Manitowoc® Parts & Service Communicator

Subject: Condensate Drain Pan Thumbscrew Causing Safety Limit #1

Product Affected: All S Models with 040000000 Serial Numbers.

Thumbscrew location for Condensate Drain Pan
(Water Curtain Has Been Removed)

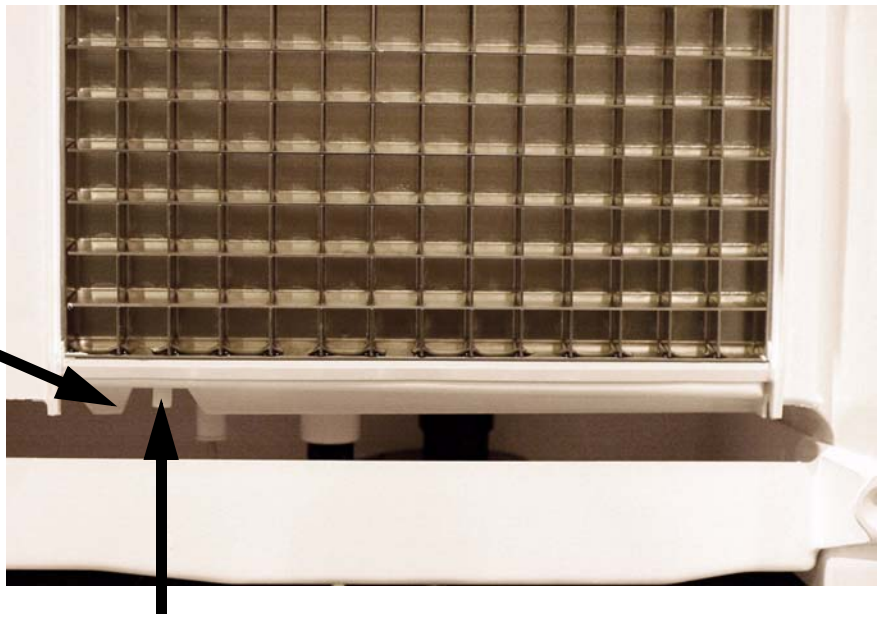
Symptom: Safety Limit #1 and there is no water present in the water trough.

Water can track past the original thumbscrew and contact the water level probe. This results in a continuously satisfied water level probe. The water inlet valve will not energize and with no water in the water trough, the ice machine stops on a safety limit #1. Verify by removing the thumbscrew and the condensate drain pan, if there is no longer a safety limit #1, the thumbscrew is the problem. If you do not have a replacement thumbscrew you can temporarily leave the machine running without the condensate drain pan until the replacement thumbscrew is obtained.

- The replacement thumbscrew (P/N 53-0512-3) directs the water to drip into the water trough.
- Replace the original evaporator tray thumbscrew with P/N 53-0512-3 thumbscrew when experiencing the symptom described above.
- All S Model ice machines manufactured starting in January 2005 have the replacement thumbscrew P/N 53-0512-3.
- Please order P/N 53-0512-3 for your inventory.
- Warranty allowance is 1/2 hour.

Replacement Thumbscrew 53-0512-3
